L-2011-150
10 CFR 50.90

Re: St. Lucie Plant Unit 1
Docket No. 50-335
Renewed License No. DPR-67

License Amendment Request for Extended Power Uprate

Figure 2.8.5.1.1-9
Increase in Steam Flow (HZP)
Peak Fuel Centerline Temperature

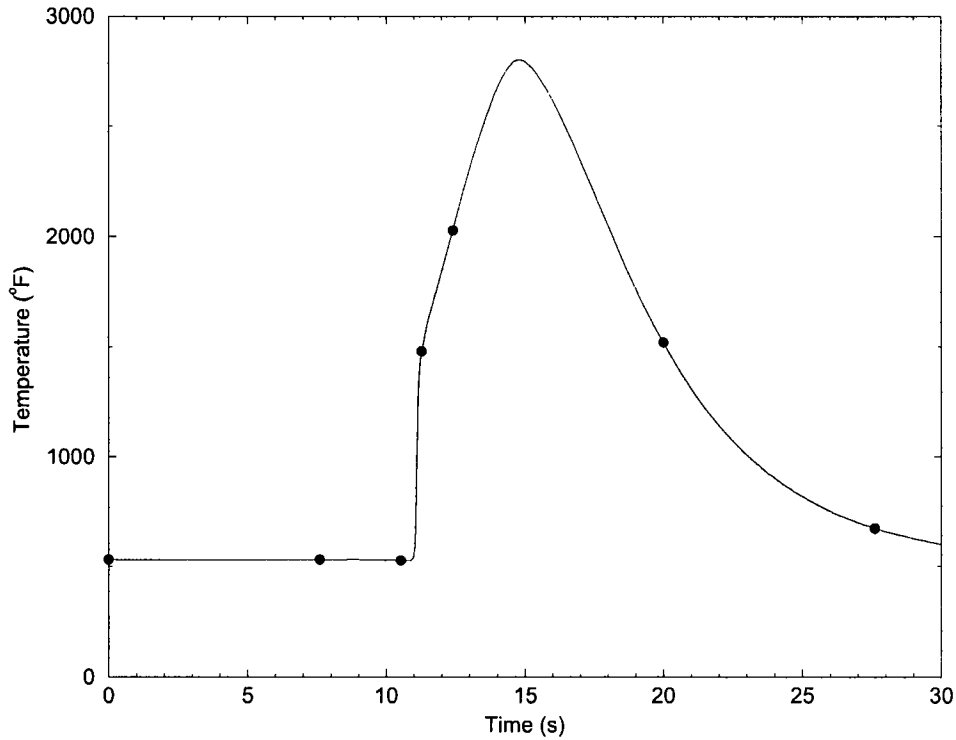
Subsequent to the November 22, 2010 submittal, FPL was notified by a supporting vendor that an error was identified in the St. Lucie Unit 1 Extended Power Uprate (EPU) Increase in Steam Flow analysis. The error affects the analysis results provided in Licensing Report (LR) 2.8.5.1.1 of Attachment 5 of FPL letter L-2010-259. Attachment 1 to this letter provides the revised pages of LR 2.8.5.1.1 with the error corrected. The revised pages consist of replacement tables and figures associated with the Increase in Steam Flow analysis results and supersede the corresponding tables and figures provided in Attachment 5 of L-2010-259. The error also affects LR 2.8.5.0 of Attachment 5 of L-2010-259; however, the impact on LR 2.8.5.0 is a conforming change only and is limited to the Table 2.8.5.0-10 summary of analysis limits and results to reflect the revised maximum centerline temperature from the Increase in Steam Flow analysis results.

Criterion	HZP	HFP	Limit
MDNBR	Bounded by HFP	1.385	1.164
Peak Centerline Temperature	2,804°F	N/A	4,623°F
Peak LHR	N/A	18.7 kW/ft	22.3 kW/ft
